**EB-2007-0709 – Hydro One Networks’ Comments on Proposed Amendments to the Distribution System Code**

**SUBMISSION OF HYDRO ONE NETWORKS INC.  
REGARDING THE BOARD'S PROPOSED CHANGES  
TO AMEND THE DISTRIBUTION SYSTEM CODE**

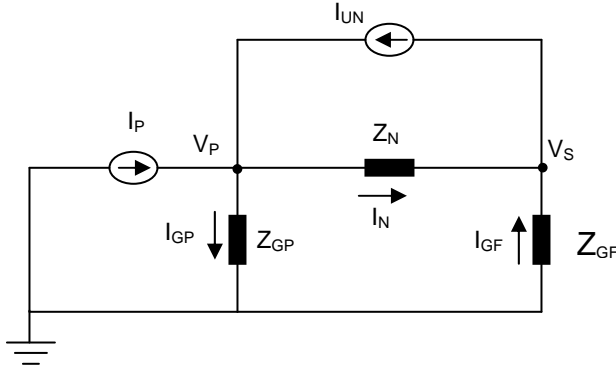
In the following example, the on-farm stray voltage source is represented by unbalance current  $I_{UN}$ . The unbalanced current returns to the supplying transformer through the LV neutral and the grounding electrodes.

The above farm electrical circuits can be modeled as the following simpler circuits. A bad LV neutral connection is taken as the example here.

$Z_N = 0.05$  ohms, representing a healthy neutral connection, or  $0.5$  ohms, representing a bad neutral connection.

$Z_{GF} = 4$  ohms, representing the aggregated farm ground impedance.

$Z_{GP} = 1$  ohms, representing the aggregated distributor ground impedance

The animal contact voltage  $V_{CC} = kV_S$ , where  $k$  is a coefficient depending on the animal contact impedance and the transfer impedance between the farm ground conductor and the animal. Here for example, we assume  $k = 0.25$ .

Since all farm loads are turned off in the proposed load box test ( $I_{UN} = 0$ ), the linear relation established by the load box test will be:

$$V_{CCD} = kV_S = 0.25 \frac{Z_{GF}}{(Z_{GF} + Z_N)} V_P \quad [1]$$

However,  $V_P$  results from both  $I_P$  and  $I_{UN}$ :

$$V_P = I_P Z_{GP} (Z_N + Z_{GF}) / (Z_{GP} + Z_{GF} + Z_N) + I_{UN} Z_{GP} Z_N / (Z_{GP} + Z_{GF} + Z_N) \quad [2]$$

**This example shows that the calculated contribution of the distributor increased by 75% because of on-farm problematic wiring.**
